AGENDA ITEM REQUEST FORM

SUBJECT TITLE: Ordinance 2011-03 Proposed Amendments to Section 30-313(4), Fences, Walls, and Hedges.

ORDINANCE 2011-03

Exhibit 2

AT-KNEE WALL FENCE

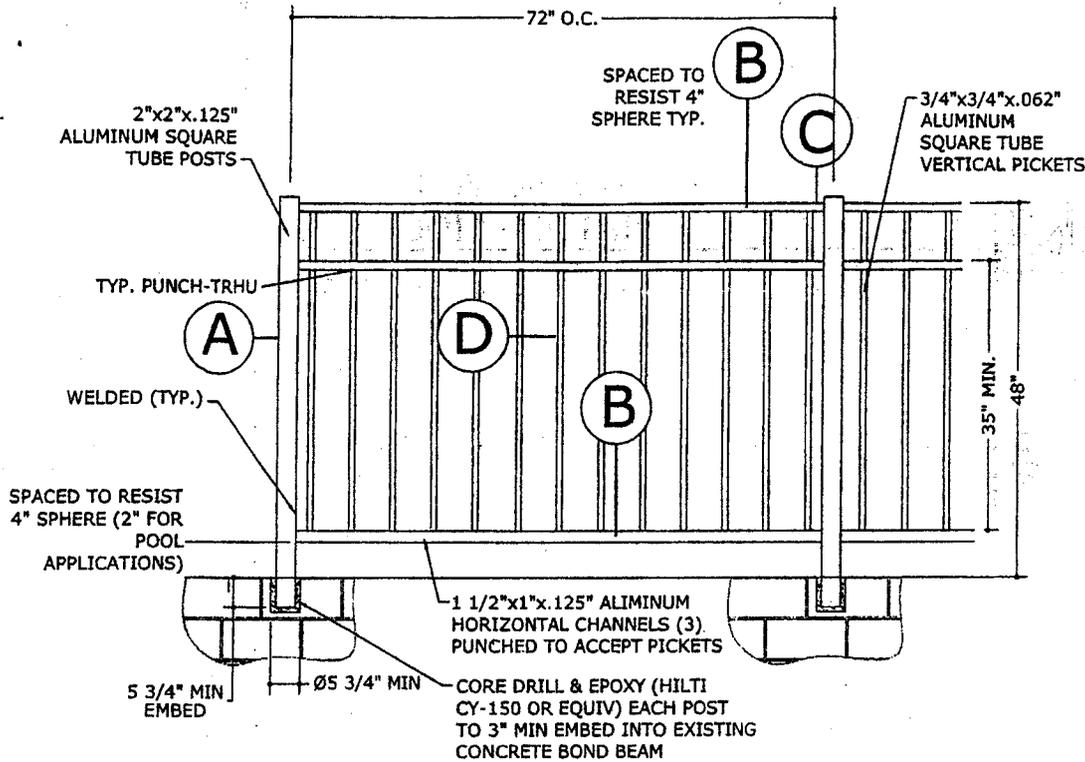
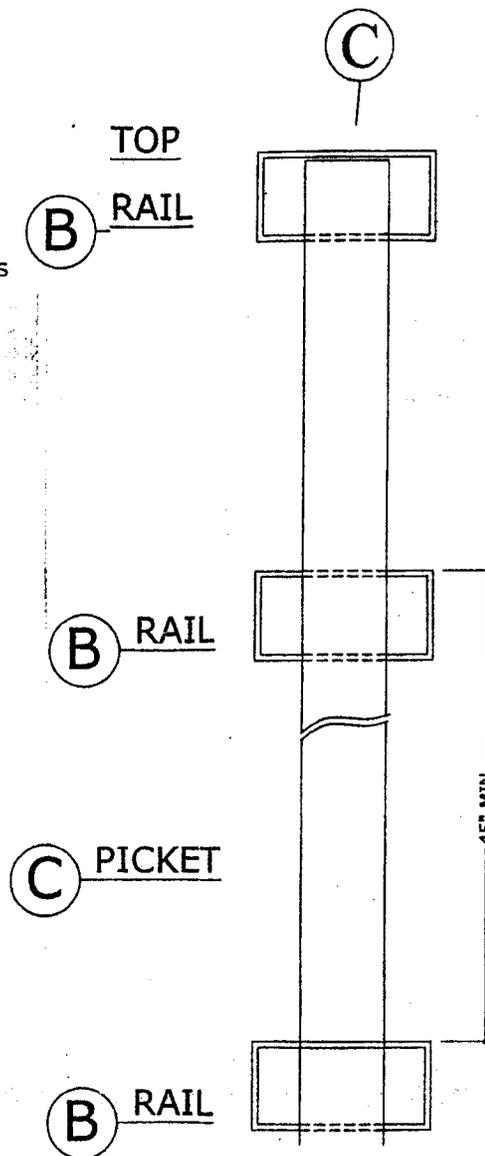
In March 2010, the El Dorado Club filed for a building permit to extend their current concrete block wall on the south property line to the east about 210 feet. The first 110 feet would be the same profile as the existing 6 ft. wall and the 100 feet closest to the east (the beach) would have a 2 ft. of concrete block topped with 4 ft. of aluminum square tube vertical pickets. A copy of the drawing showing the fence is attached.

The permit was turned down because our Code (section 30-131.(4).d requires that concrete walls have at least 25% of their area constructed with decorative brick and provide openings to permit air circulation. All concrete and cement walls shall be stuccoed, finished and painted.

The Town staff has interpreted the Code to mean that at least 25% of each section of the wall must permit air circulation. The proposed wall with the aluminum pickets is open and allows air circulation for 32% of the total wall area, but it does so in the last 48% of the wall. Even if we rethink how we interpret the Code, we don't see an alternative to the Code language that the 25% "opening" has to be decorative brick.
